D.H.O. FOUNDATION INVESTIGATION
REPORT.
W.J. 62-F-27 -- W.P. 242-61.

Re: Plains Road E. (Old Q.E.W.) & C.N.R.,
Line 'A' - In Town of Burlington,
District No. 4.

Re: C.N.R. Overhead and

Plains Road - W.P. 242-61.

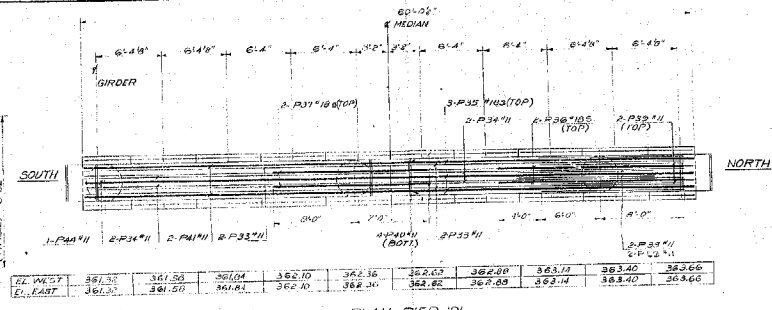
We have reviewed the preliminary plan D-5085-P1 for the above structure and herewith submit our suggestions concerning the type of footing for your consideration:

The subsoil at the proposed bridge site is undoubtedly of very good properties.

The upper two layers, the clayey silt with sand and gravel and the sandy silt are very dense and have therefore a high bearing capacity. The underlying shale of course is also a very competent material.

In our report we have recommended spread footings at approx. 5 ft. below groundlevel (elev. 323.0) and a safe load of 3.0 tons sq. ft. This load is definitely on the very conservative side and could be increased up to 5 tons if required.

From the drawing we understand that a maximum load of up to 600 tons per three columns is to be expected. Equally divided a load of 200 tons will have to be supported by each column. If a 6x8 spread footing is designed a bearing load of 4.2 t.s.f. would act on the subsoil. Since the columns are asymmetrical the loads that they carry will be different, and the footings should be designed accordingly, namely, to allow the same bearing load to act on the subsoil.

As an alternative to this solution drilled-in and cast-in-place piles are suggested. Those piles can be continued above groundlevel and used as columns. They would be bearing piles drilled some 5 feet into shale bedrock to avoid the upper possibly softened and weathered zone. If 3 ft. diameter piles are used the bearing pressure on the shale

would be slightly less than 30 t.s.f. Experience with bearing on shales in Hamilton would indicate that such a pressure is not excessive and is therefore allowable.
